AQUALLIANCE

April 23, 2022

Re: Corning Subbasin Groundwater Sustainability Plan

Modified Table 4D-35. Corning Subbasin Projected 2070 Land Surface Budget, Annual Average by Water Year Type

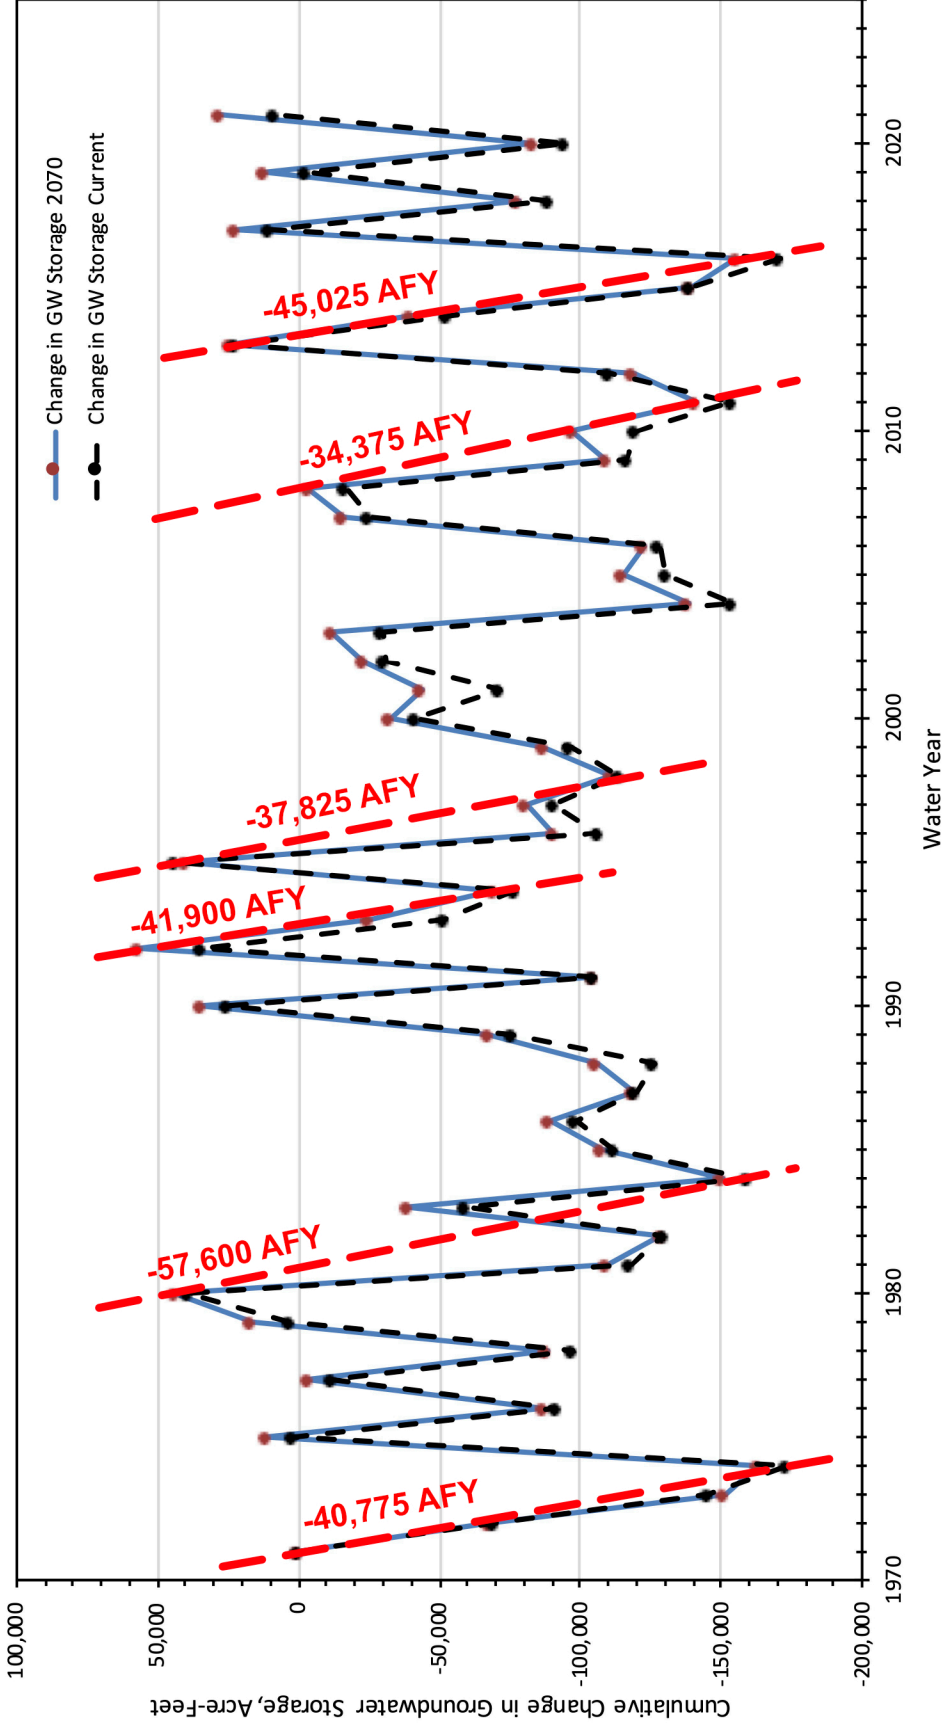
8. AquAlliance Exhibit 5 gives the values for the Land Surface Budget for the Historical baseline, part A, and the projected 2070 scenario, part B. The differences between the baseline and the 2070 scenario are given in part C. Overall there is an increase in the total inflow and outflow with the 2070 scenario, Exhibit 5C (rows 26 and 31, columns C through J). However, the direction of change is not the same for each water budget component.

The 2070 scenario inflow for precipitation and applied groundwater both increase over the Historical baseline, but the applied surface water decreases. For the 2070 scenario the total outflow increases with the increases in evapotranspiration and overland flow. These increases in outflow appear to cause the decrease in deep percolation and return flow to streams, Exhibit 5C (rows 27 and 30, columns C through J). The total change in soil and unsaturated zone storage from Historical baseline to the 2070 scenario is negative for the annual average and the BN/AN water year, positive for the CD/D drought water years, and zero for the wet years, Exhibit 5C (row 32, columns C through J). It is unclear if the loss in return flow to streams in the Land Surface Budget, Exhibit 5 (row 30), is a part of the net stream gains component in the Groundwater and Surface Water budgets, Exhibits 2, 3 and 4.
